Technical Service Bulletin

40 Technical changes on front and rear axle

40 13 33 2026402/2 August 16, 2013. Supersedes Technical Service Bulletin Group 40 number 11-18 dated July 14, 2011 for reasons listed below.

Model(s)	Year	VIN Range	Vehicle-Specific Equipment
R8	2008 – 2010	All	Not Applicable
R8 / R8 Spyder	2011	000001 - 002563	Not Applicable

Figure 1. Tools used when installing links with bonded rubber bushings

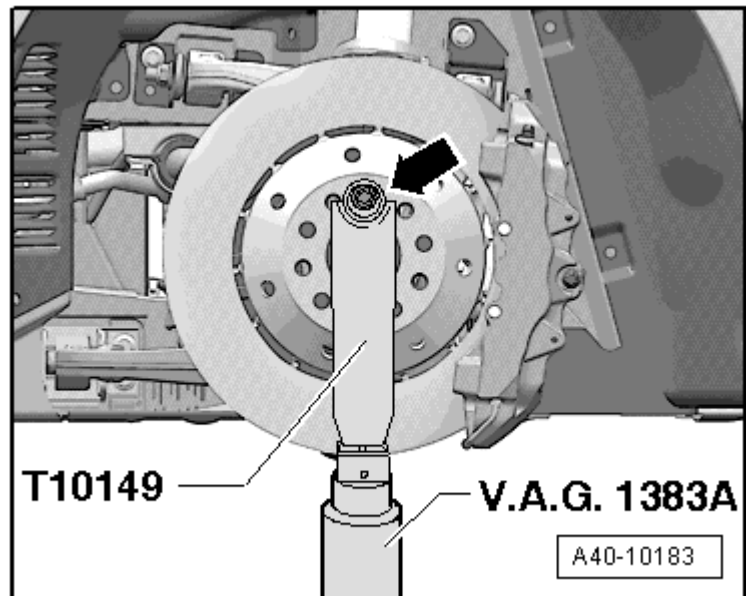
As explained in Elsa, it is essential to simulate the curb height when reassembling the suspension links with bonded rubber bushings (Figure 1).
